Request for Additional Information No. 546(6407), Revision 0

U. S. EPR Standard Design Certification

Docket No. 52-020

SRP Section: 06.02.02 - Containment Heat Removal Systems

Figure D.3-5: Corrosion of Aluminum A1100

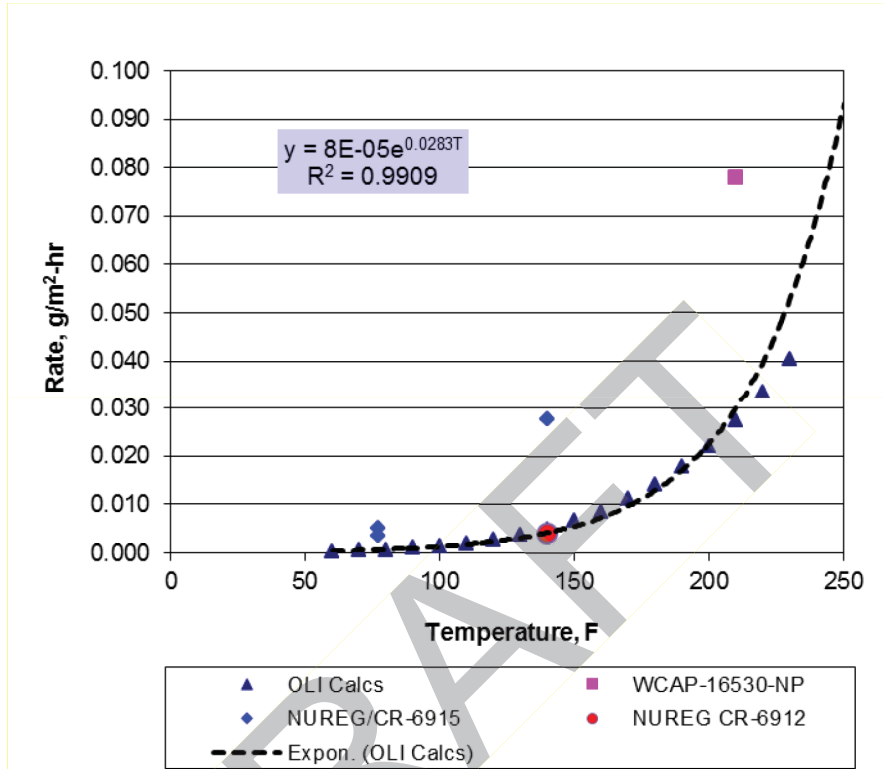
The staff requests that the applicant clarify the source the two data points labeled “WCAP-16530-NP, pH 7” on Figure D.3-5 in ANP-10293P, R4. The corrosion rates for these points, as plotted in the figure, are approximately 0.005 g/m²-h at 150°F and 0.078 g/m²-h at 220°F. Using WCAP-16530-NP-A, Equation 6-2, the staff calculated release rates of 0.12 g/m²-h at 150°F and 1.49 g/m²-h at 220°F. The figure shows good agreement between the WCAP data points and the OLI calculations, but the staff was not able to confirm this from the information in the WCAP.

The table below summarizes the discrepancy between the WCAP data points (pink squares) in Figure D.3-5 and the staff’s calculations.

T, °F	<u>Corrosion Rate</u>		<u>Corrosion Rate</u>
	Staff calculation		Figure D.3-5 of ANP-10293P-R4
	mg/m ² -min*	g/m ² -hour	g/m ² -hour (approx.)
150	2.042	0.12	0.005
220	24.87	1.49	0.078

Equation 6.2 of WCAP-16530-NP was not utilized in the calculation of the aluminum release rates because it greatly over-predicts aluminum releases in neutral solution. Rather, the data points from the literature represent experimental data collected for aluminum in neutral solutions.

The first data point (140°F, pH 7) was incorrectly identified as sourced from WCAP-16530-NP. The data point (0.0039 g/m²-h or 0.065 mg/m²-min) is given in NUREG CR-6912, Table A-4.

The second data point (210°F, pH 7) at 0.078 g/m²-h (1.3 mg/m²-min) comes from WCAP 16530-NP, Table 6.2-1.

Technical Report ANP-10293P, Revision 4, will be revised at a later date as shown below.

Figure D.3-5 of ANP-10293P should be as follows.
